# West Burton Solar Project

### Figure 8.18.1: Landscape and Ecology Mitigation and Enhancement Measures West Burton 1 Revision A

PINS reference: EN010132  
Document reference: EX1/WB6.4.8.18.1\_A  
APFP Regulation 5(2)(a)

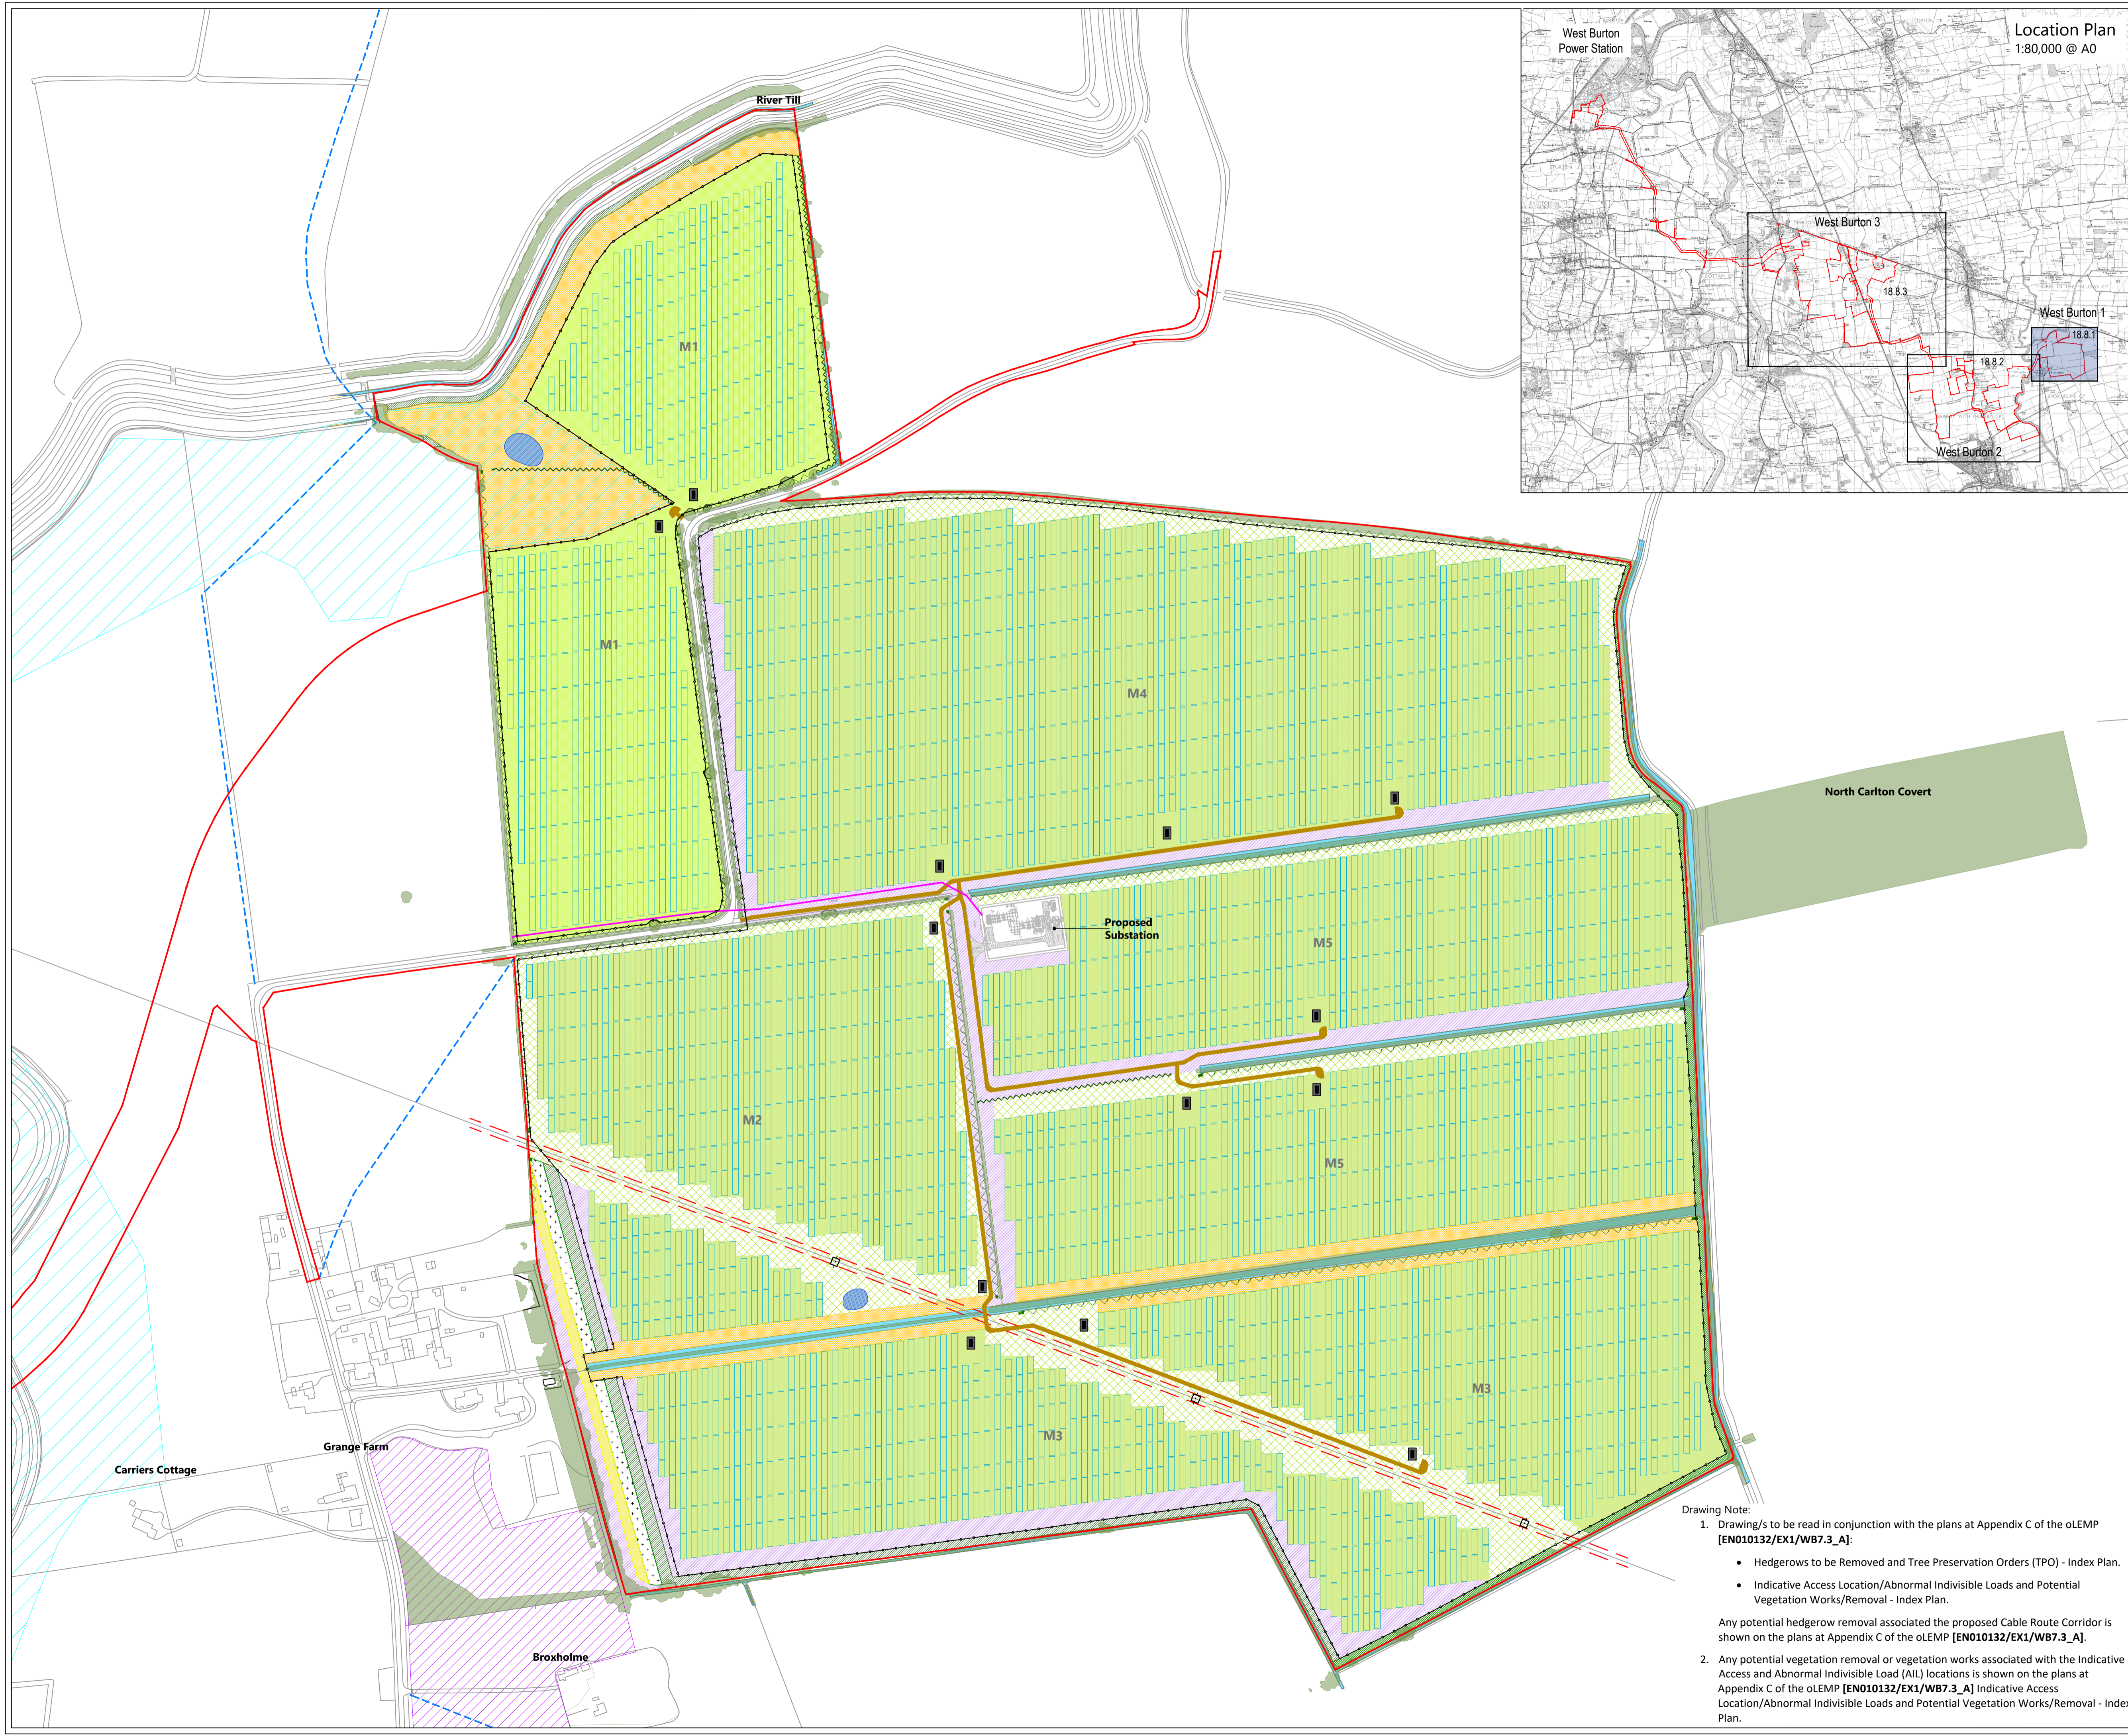
Figure Reference	Page	Description of Changes	Reason for Revision
WB6.4.8.18.1_A	3	<p>Change to spelling of 'enhancement'.</p> <p>Amend the wording of hedgerow removal in the key from 'Existing hedge to be removed' to 'Existing hedge to be removed permanently'.</p> <p>Offset calculations from drains.</p> <p>Changes to hedgerow removal locations.</p> <p>Changes to proposed woodland planting.</p>	<p>To correct a typo.</p> <p>For clarity.</p> <p>For clarity.s</p> <p>For clarity.</p> <p>In response to changes to proposed cable route and tracks</p>
